Office Action Summary	Application No. 10/518,521	Applicant(s) NIKUNEN ET AL.	
	Examiner Carl D. Price	Art Unit 3749

DETAILED ACTION

A method of generating a flame in a combustion zone of a rotary kiln comprising:

JP 51- 136716 shows:

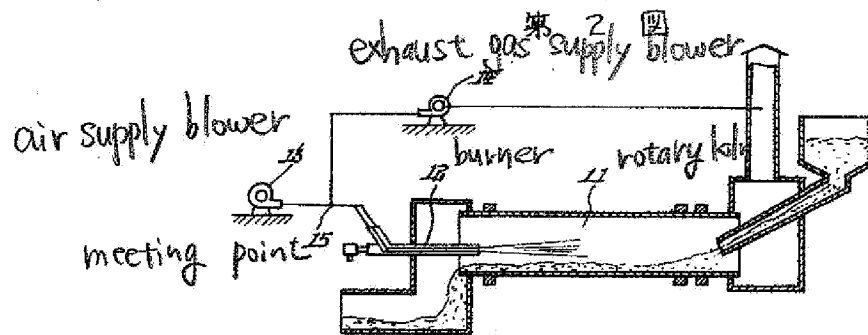
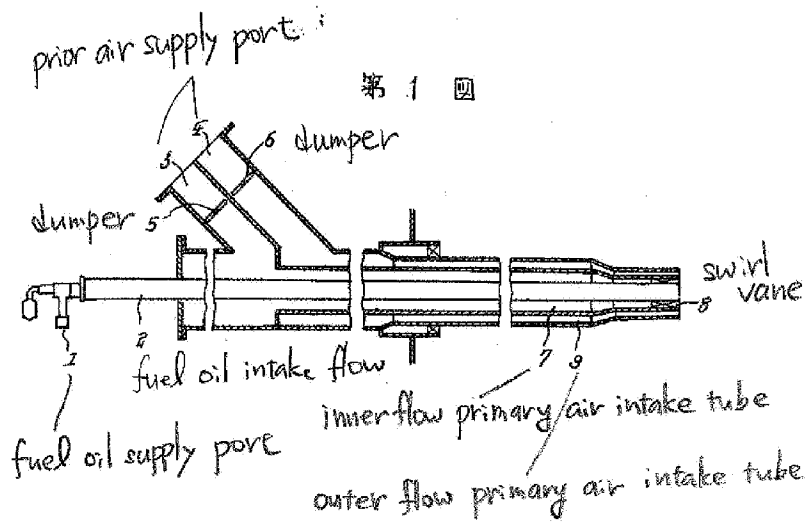
JP 51- 136716 shows and discloses a burner lance (2) is provided for introducing fuel into the burner tube (9) for combustion with primary air to generate a flame at the discharge end of the burner tube within the combustion zone of a rotary kiln (11), and wherein a flue gas (14) is directed to the burner tube so that the flue gas is used as primary air for combustion of the fuel introduced into the burner tube by the burner lance where it is combusted with the fuel as primary air to generate a flame at the discharge end of the burner tube in the combustion zone of the rotary kiln.

JP 51- 136716 shows and discloses the invention substantially as set forth in the claims with possible exception to:

- an external turbine flue gas source for the flue gas source.

In regard to **claim 1-4, 6-9, 11-14, 16** and **17** for the purpose of providing a suitable alternative flue gas supply for aiding in reducing the formation of NO_x during combustion, it would have been obvious to a person having ordinary skill in the art to substitute an external turbine flue gas source for the flue gas source (14) of **JP 51- 136716** in view of the teaching of **JP 07-208705**) or **DE 100 62 066**.

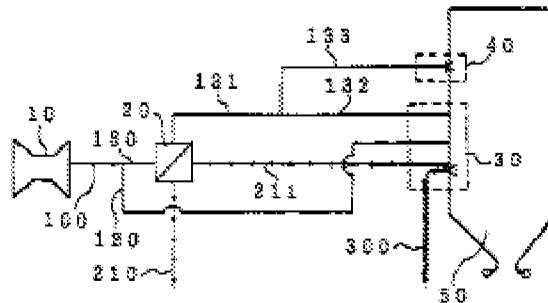
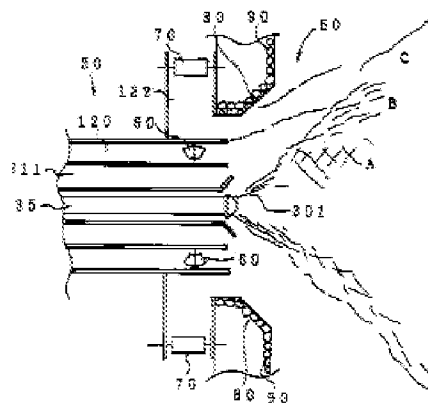
JP 07-208705 teaches, from applicant's same combustion fired furnace field of endeavor, a burner lance (35) is provided for introducing fuel into the burner tube for combustion with primary air to generate a flame at the discharge end (80, 301) of the burner tube, and wherein a flue gas (120) generated by a gas turbine (10) located outside the kiln wall (90) which in turn is directed to the burner tube so that the flue gas is used as primary air for combustion of the fuel introduced into the burner tube by the burner lance where it is combusted with the fuel as primary air to generate a flame at the discharge end of the burner tube in the combustion zone of the rotary kiln."

DE 100 62 066 shows:

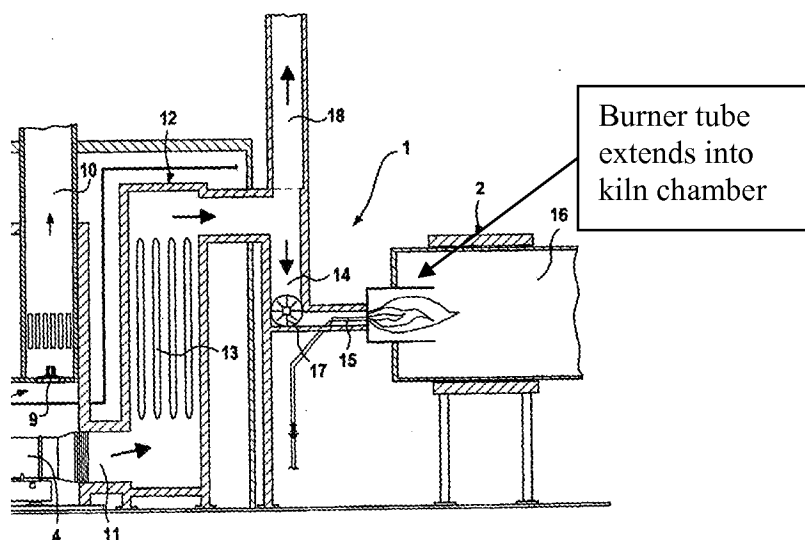
DE 100 62 066 teaches, from applicant's same combustion fired furnace field of endeavor, a burner lance (15) is provided for introducing fuel into the burner tube (not referenced) for combustion with primary air to generate a flame at the discharge end (not referenced) of the burner tube, and wherein a flue gas (11, 12, 14) generated by a gas turbine (4) located outside the kiln wall (16) which in turn is directed to the burner tube so that the flue gas is used as primary air for combustion of the fuel introduced into the burner tube by the burner lance where it is combusted with the fuel as primary air to generate a flame at the discharge end of the burner tube in the combustion zone of the rotary kiln. **DE 100 62 066** discloses a cement manufacturing installation comprises a rotating oven (2) having a rotating pipe (16) heated using a burner (15); and a gas turbine arrangement (4) driven by a generator to produce electrical energy. A pipe connection (12) is arranged between an exhaust gas outlet (11) of the gas turbine

arrangement and a combustion air inlet (14) of the burner. The exhaust gas is introduced as combustion air via the pipe connection.

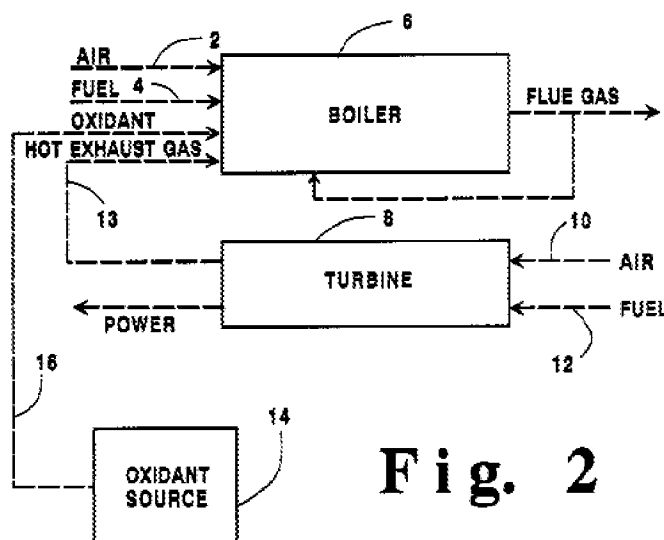
In regard to claim 12, **JP 51- 136716** includes an air fan (13) which would necessarily and inherently provide a relatively cool flow of air supply to the burner tube.
